Design Commission Hearing Topic

PROJECT SUMMARY

The proposed development is for a 15-story multi-family apartment building located at the southwest corner of NE 7th Avenue and NE Oregon Street in the Lloyd District. Tax lot 1N1E35BC2200 is currently occupied by an office building. Tax lot 1N1E35BC2100 is vacant.

Public Art | water-themed etched glass installation, integrated into glazing system with translucent glass and lighting from canopy above

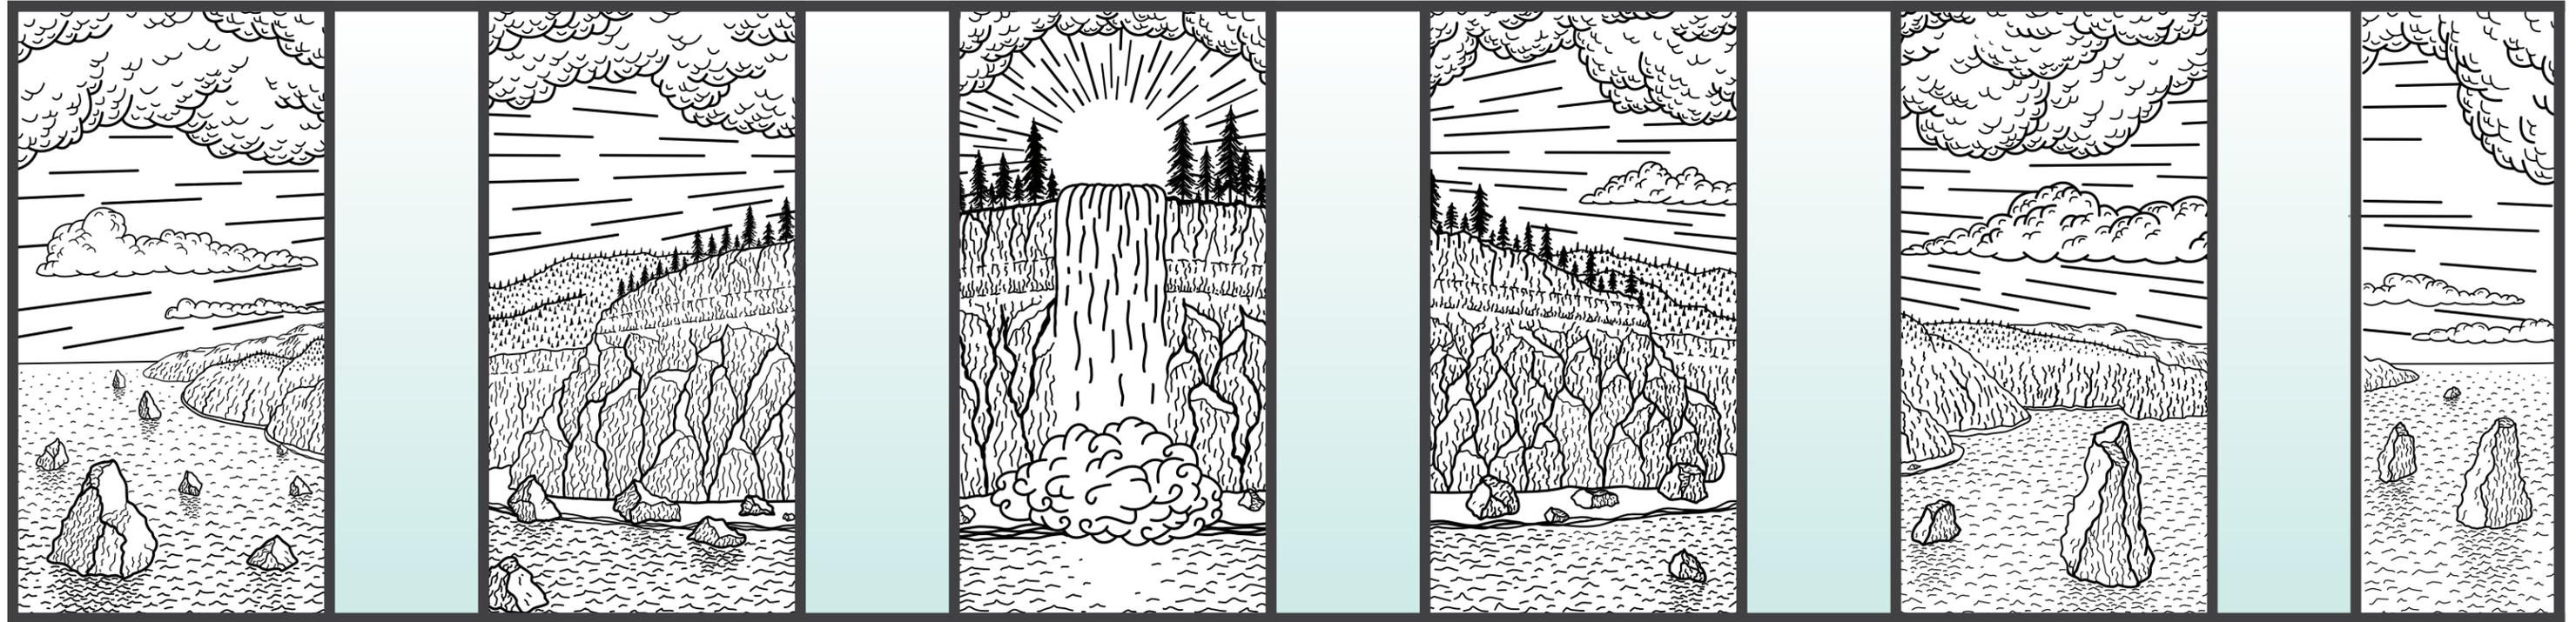
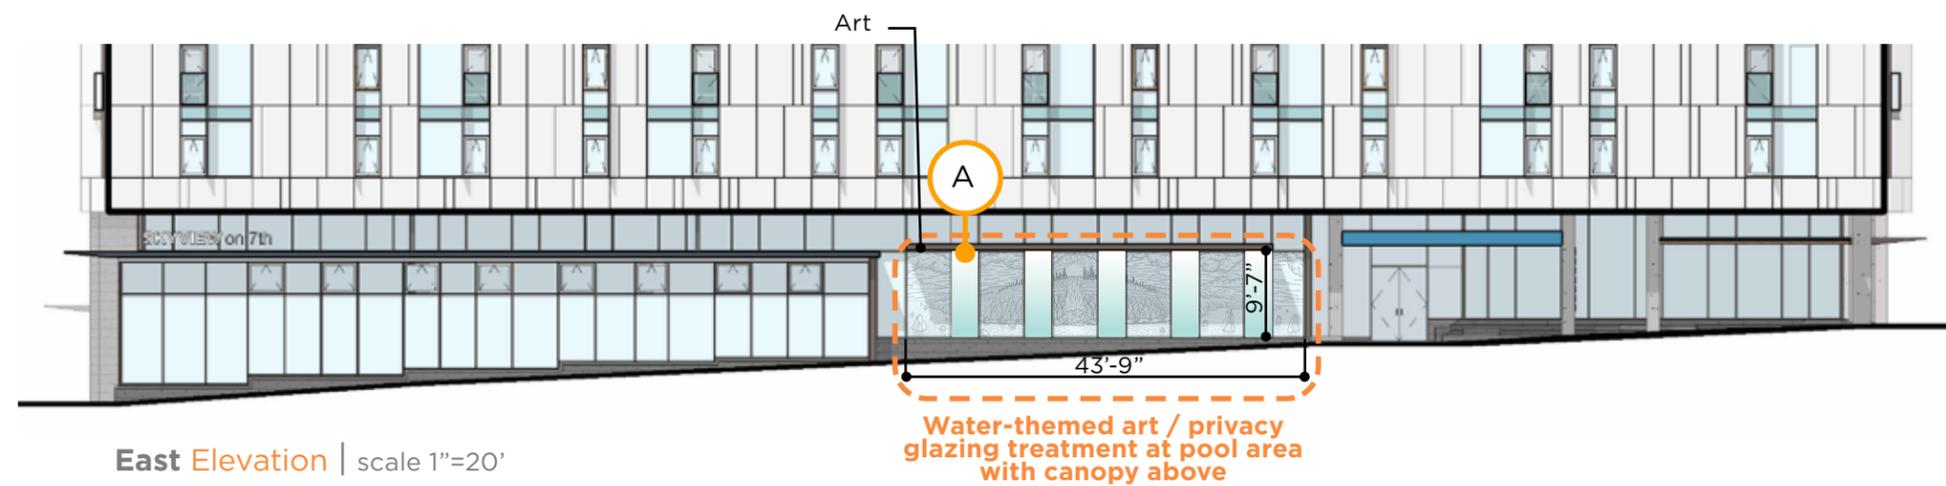
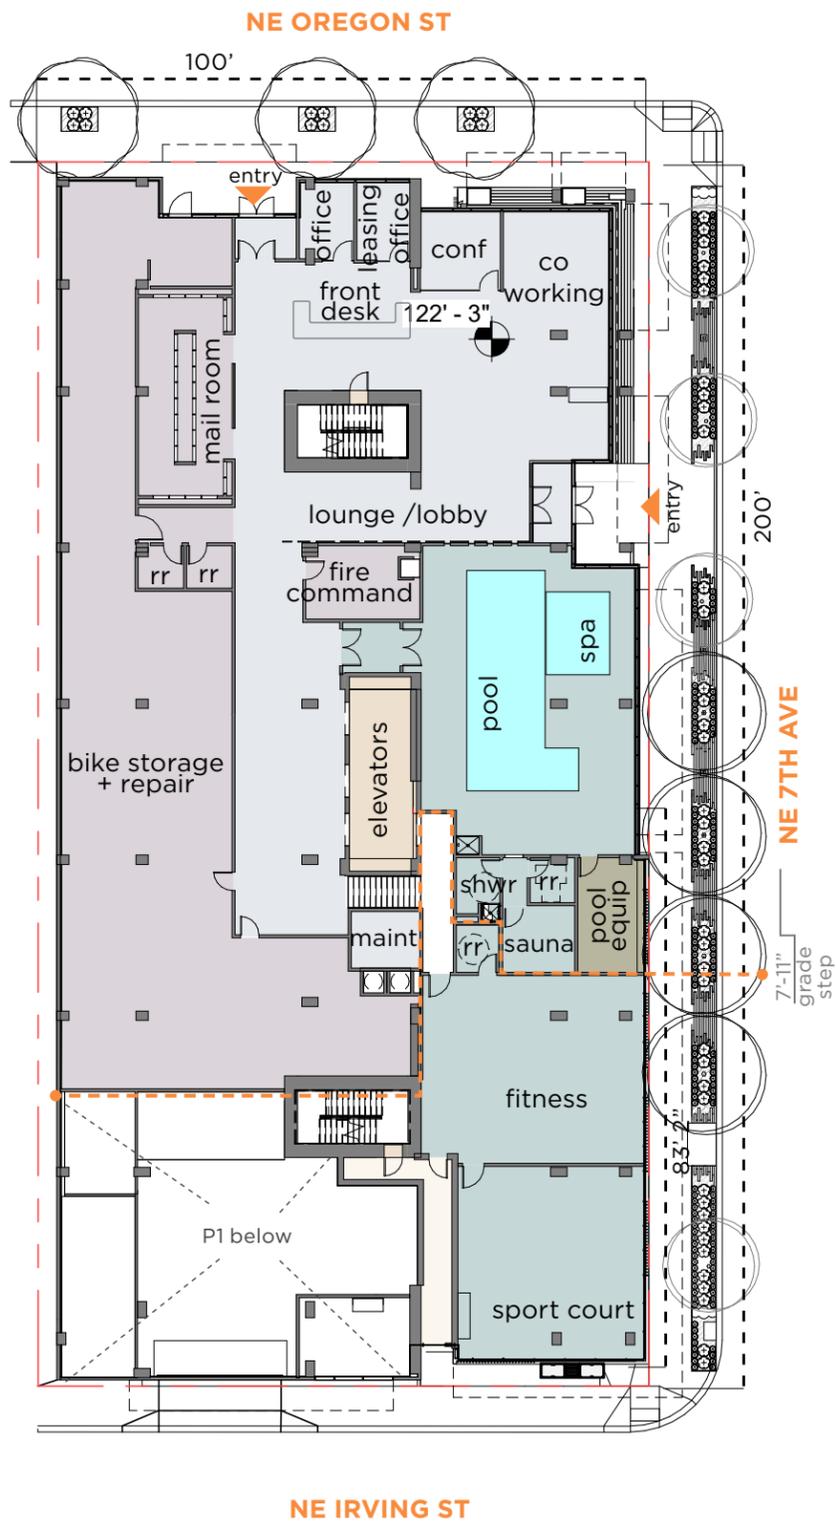
1. Response to required public Art and Water feature guidelines

- The applicant commissioned an artist to design a water-themed public art piece, consisting of a large-scale mural etched into the glass at the pedestrian level on the east elevation. The placement coincides with the location of the Pool and Spa tenant amenity to highlight the program while moderately obscuring visibility of the occupants.

- Graphics of the art design are in the design packet (Sheets C.13, C.25, and APP.14). The canopy over the public art includes integrated lighting as detailed on Sheets C.22-B, C.21, and C.26.
